Subject: Tire Pressure Monitoring System, Antenna Update

Number: 04-02

Model(s): Touareg with Tire Pressure  
Monitoring System

Date: May 20, 2004

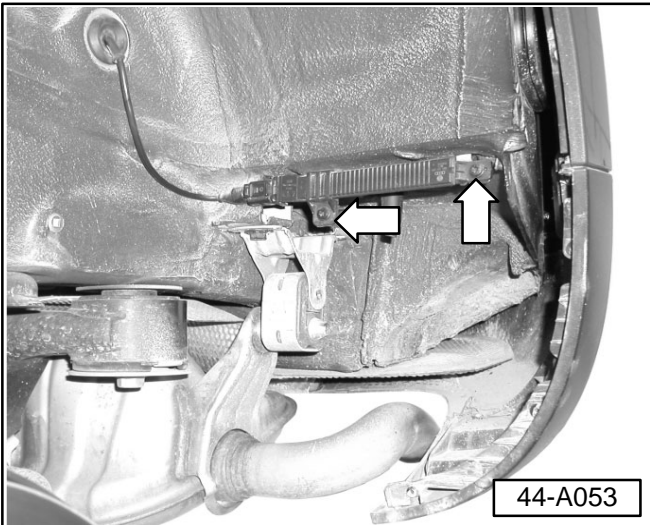
◀ If Tire pressure monitoring antenna is in revised location -arrow-:

If Tire pressure monitoring antenna is in original location:

- No Service Action is required. DO NOT complete this technical bulletin.

- Perform the following two steps in order.

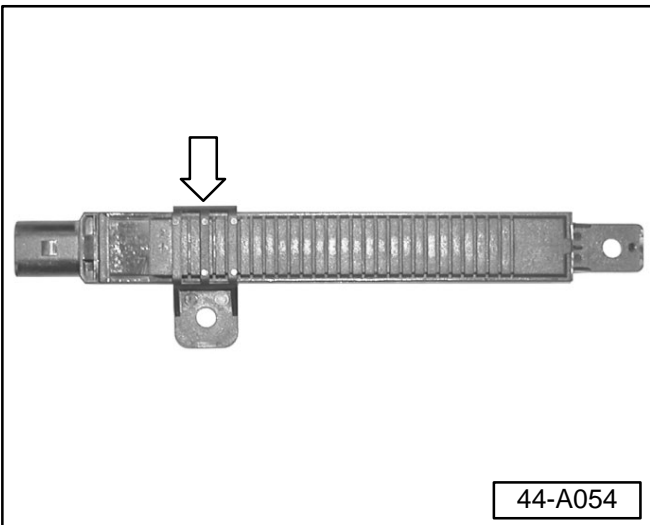
◀ - Remove both mounting bracket fasteners (arrows).

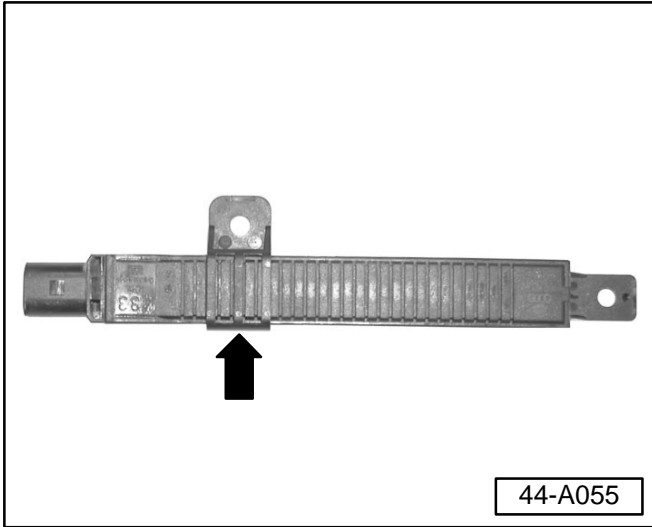
◀ - Remove fastener bracket from old location (arrow).

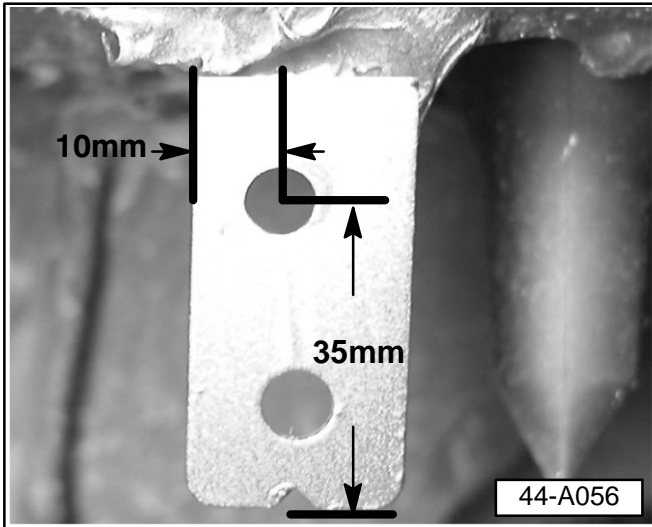
◀ – Flip bracket and install as shown (arrow).

◀ – Mark Antenna Mounting bracket in location as shown.

– Drill mounting bracket using a 6.35mm (1/4 inch) drill bit and remove any burrs from the hole.

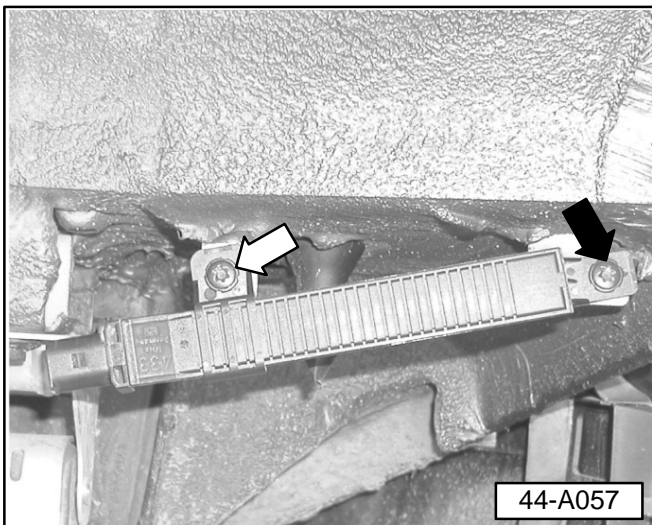
◀ – Assemble Antenna to bracket after allowing 15 minutes of paint drying time.

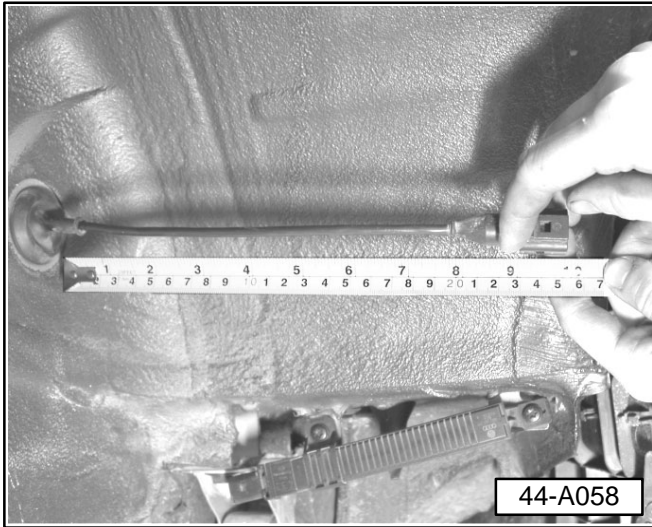
*First, install fastener at fixed point (black arrow), then slide bracket on antenna as necessary to align second fastener (white arrow).*
